SECTION 00 91 13.2 – ADDENDUM 2

- A. Project Name: Hendricks County Coroner Office.
- B. Owner: Hendricks County Board of Commissioners.
- C. Architect: arcDESIGN, PC.
- D. Architect Project Number: 23158.
- E. Date of Addendum: December 22, 2023 .

5A DEMO REFLECTED CEILING PLAN - FIRST FLOOR
3/16" = 1'-0"

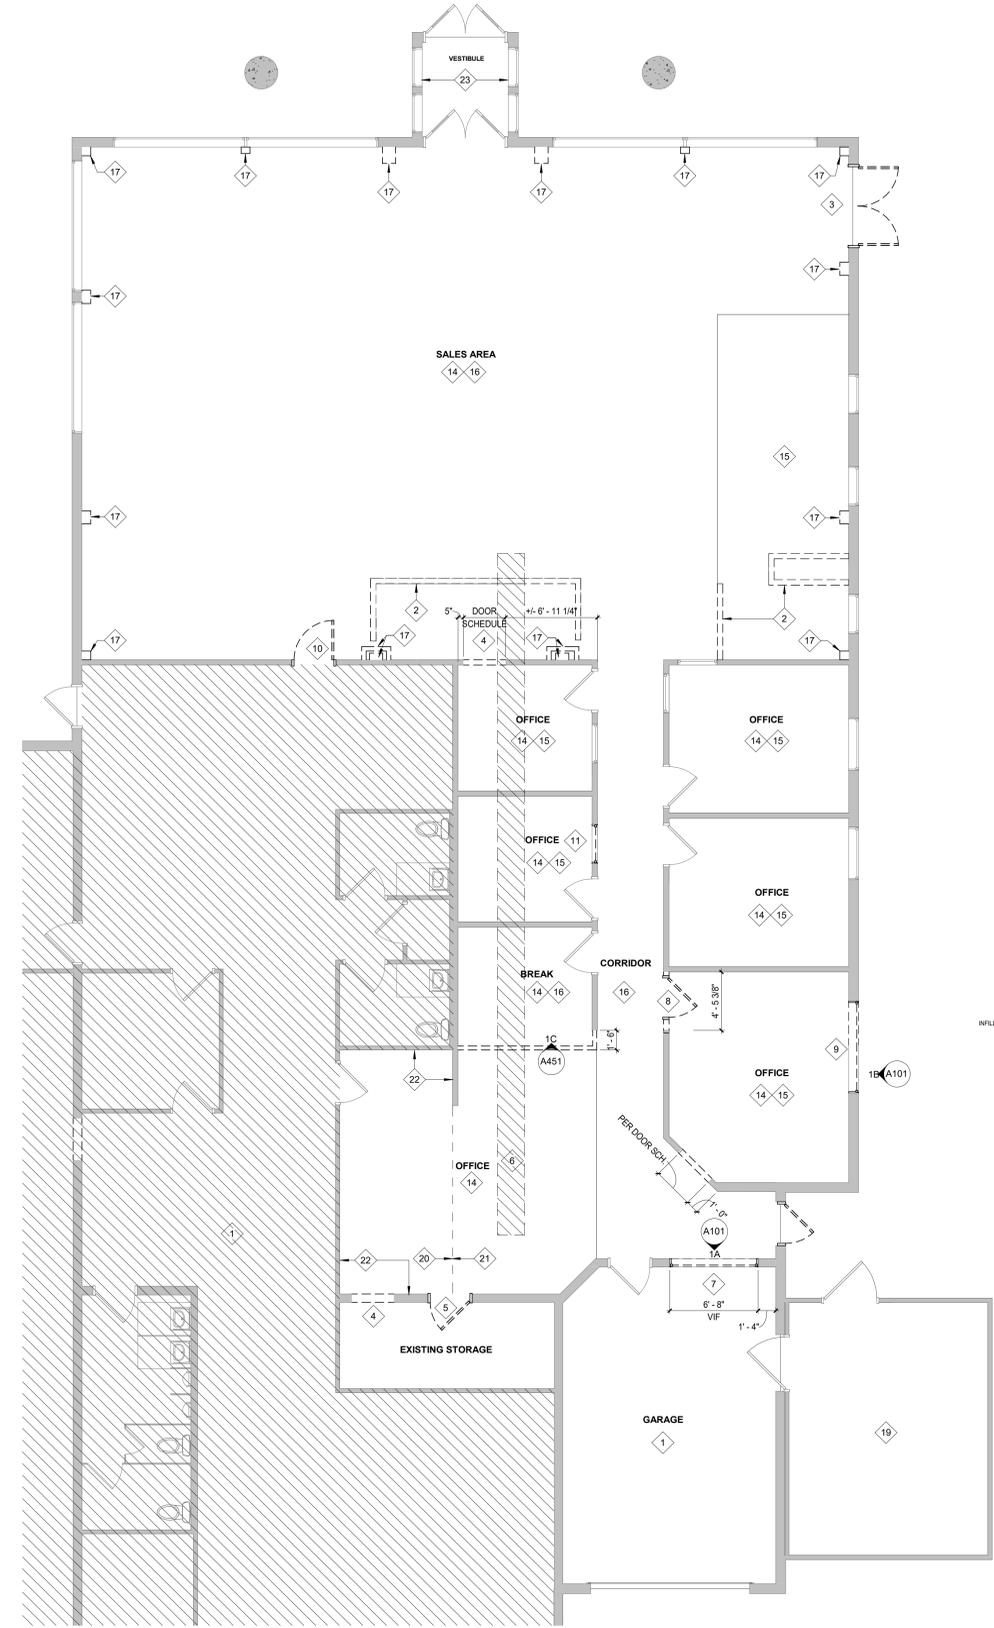
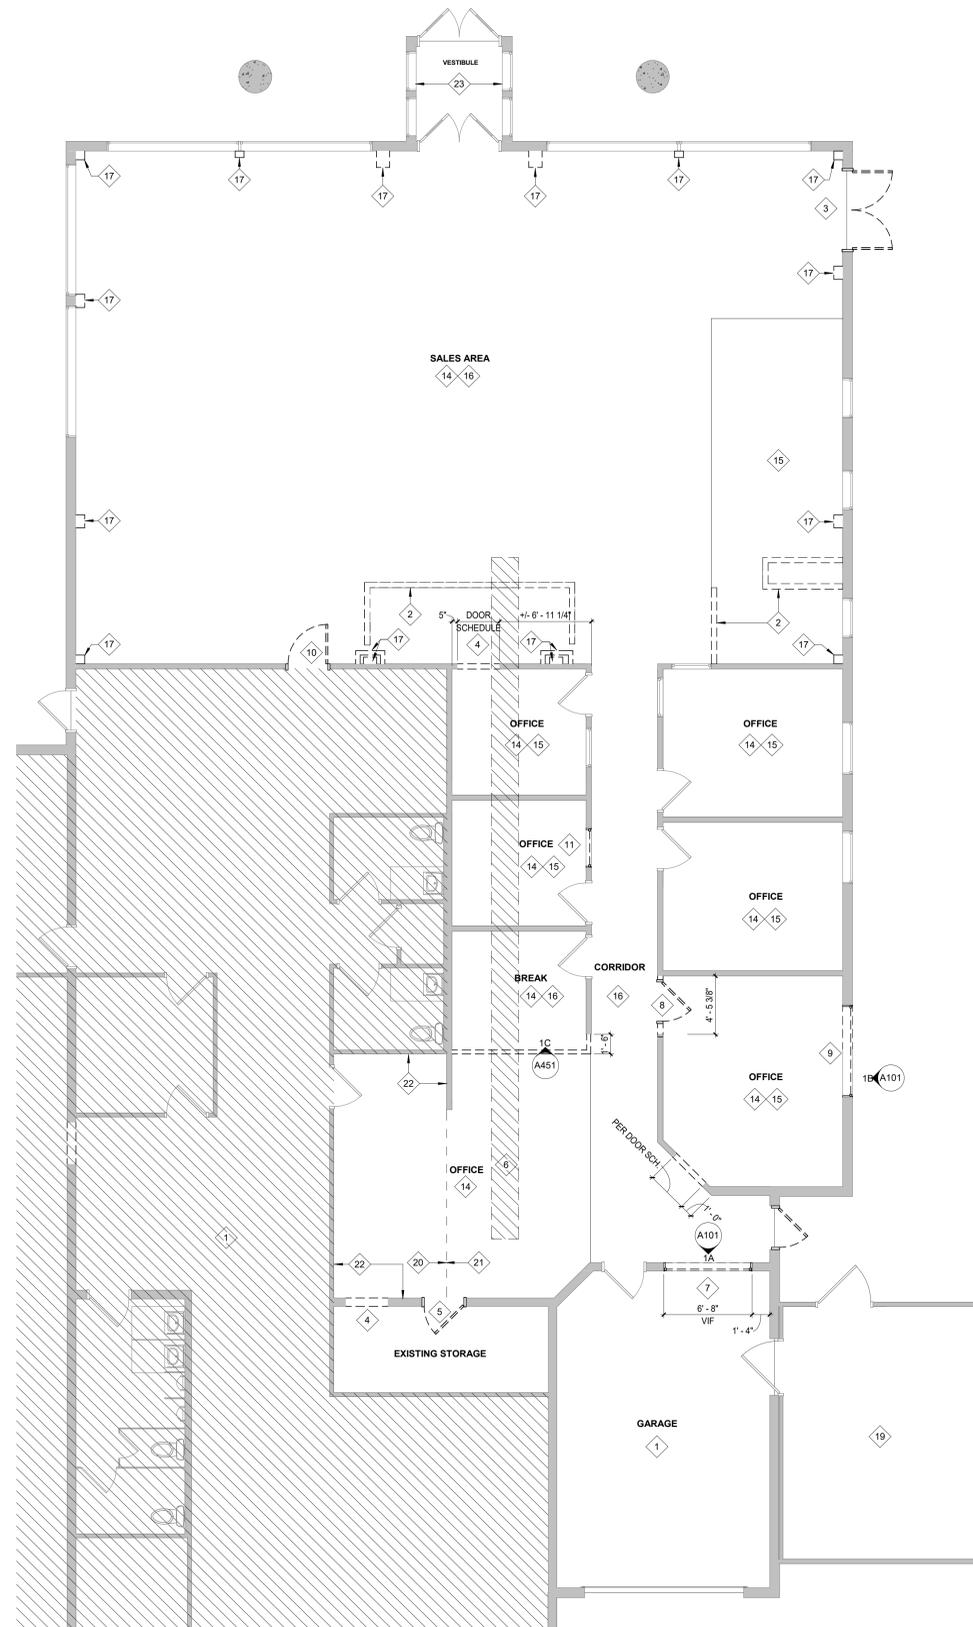
- A. Sheet A101 – DEMOLITION PLAN (reissued).
 - 1. Drawing 5A DEMO REFLECTED CEILING PLAN – FIRST FLOOR: Swapped demo note 12 for demo note 13 in GARAGE 116.

3A DEMOLITION PLAN - FIRST FLOOR
3/16" = 1'-0"

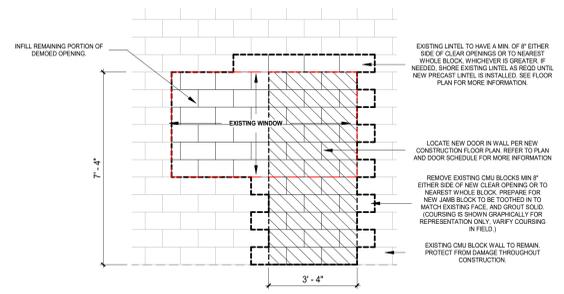
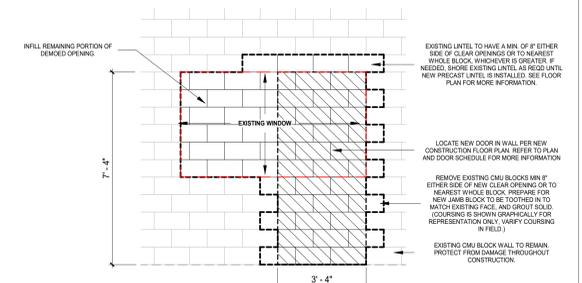
- 2. Drawing 3A DEMOLITION PLAN – FIRST FLOOR : Revised demolition note 14.
- B. Sheet A131 – REFLECTED CEILING PLAN (reissued).
 - 1. Drawing 3A REFLECTED CEILING PLAN: Revised ceiling graphics to reflect ceilings existing to remain. Adjusted the height of select ceilings.

- 14 PATCH AND REPAIR TO LEVEL 4 FINISH AT EXISTING GYPSUM BOARD TO REMAIN. ~~REMOVE EXISTING CARPET AND RESILIENT BASE, GYPSUM BOARD AND CLEAN SUBSTRATE TO PREP FOR NEW FINISH.~~

MECHANICAL PLAN
3/16" = 1'-0"

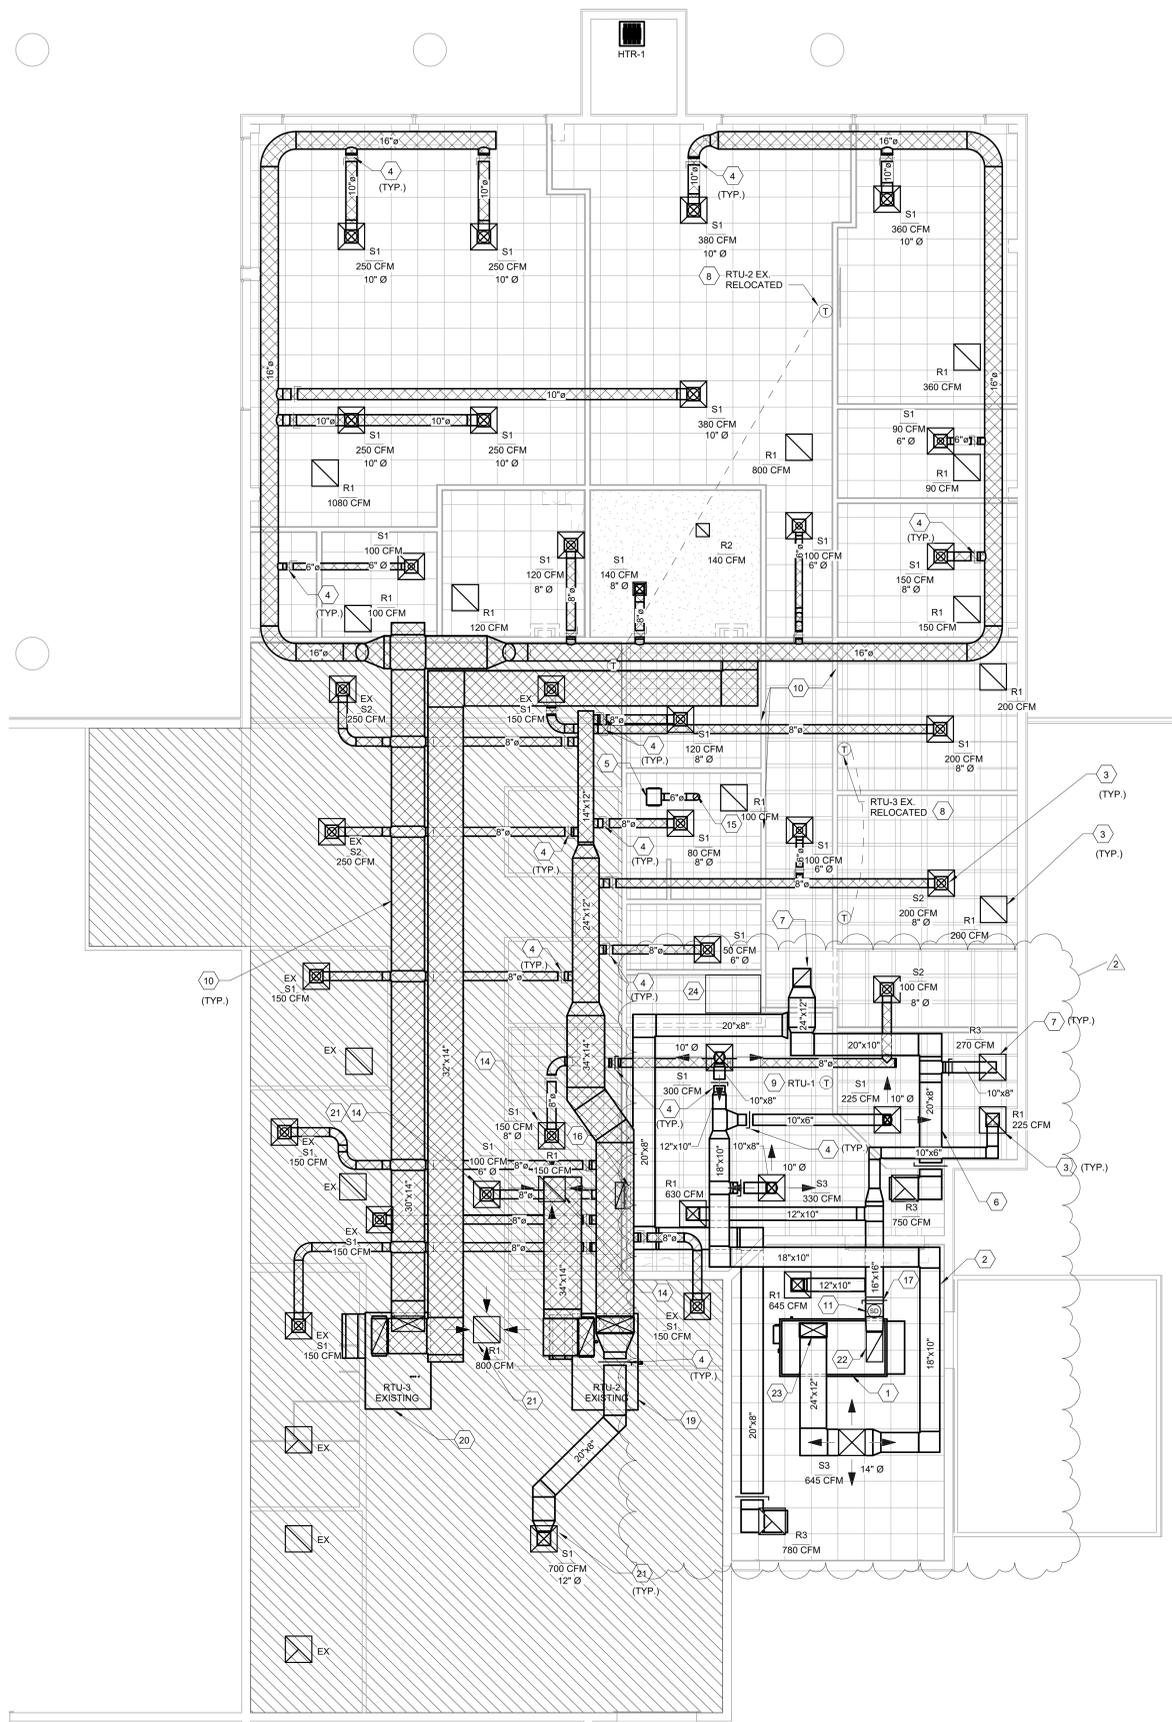
- D. Sheet M101 – MECHANICAL PLANS (reissued).
 - 1. MECHANICAL PLAN – Revised ductwork over Autopsy Suite and garage.
- E. Sheet E101 – LIGHTING PLAN (reissued)

LIGHTING PLAN
3/16" = 1'-0"

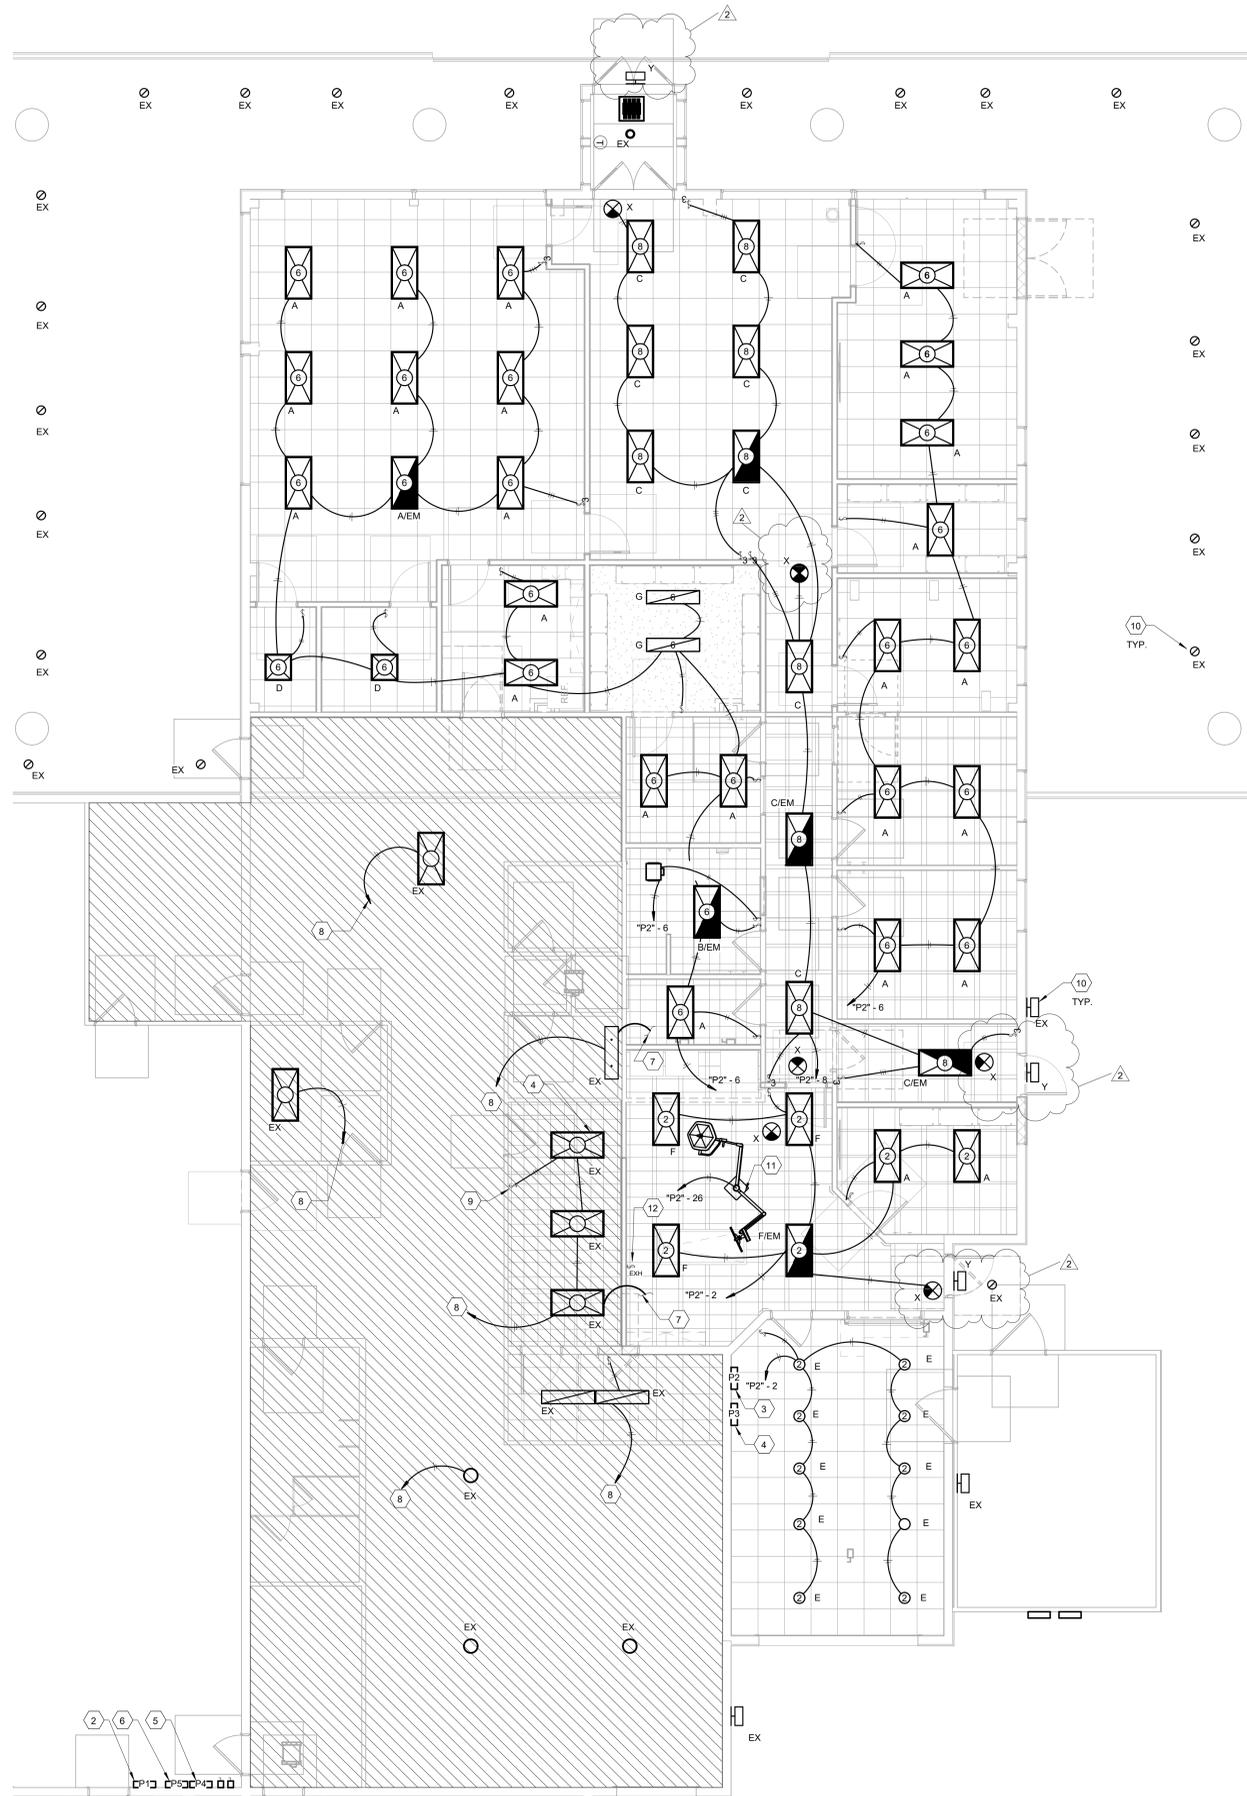
- 1. LIGHTING PLAN – Added graphic representation of fixture Y to all exits.
 - 2. LIGHT FIXTURE SCHEDULE – Revised fixture X and Y.

- F. Question: Is the contractor providing the surgical light? If so, please provide a specification.
 - 1. Answer: Contractor is providing a surgical light. See key-note 11, sheet E101 for specification.

- G. Question: Is the contractor providing a remote outdoor emergency light for exit doors?
 - 1. Answer: Contractor is to provide a remote head. See Light fixture schedule for specification. These will be placed at each of the three exterior doors.

TELEPHONE/DATA CONDUIT DETAIL
NOT TO SCALE

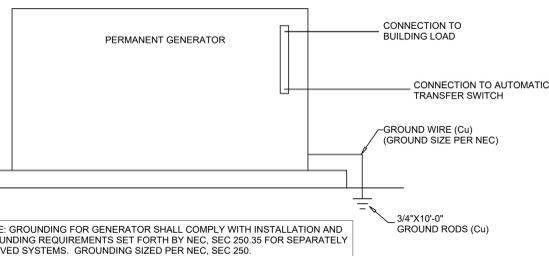
- F. Sheet E202 – ELECTRICAL RISER AND DETAILS (reissued)
 - 1. Added TELEPHONE/DATA CONDUIT DETAIL.
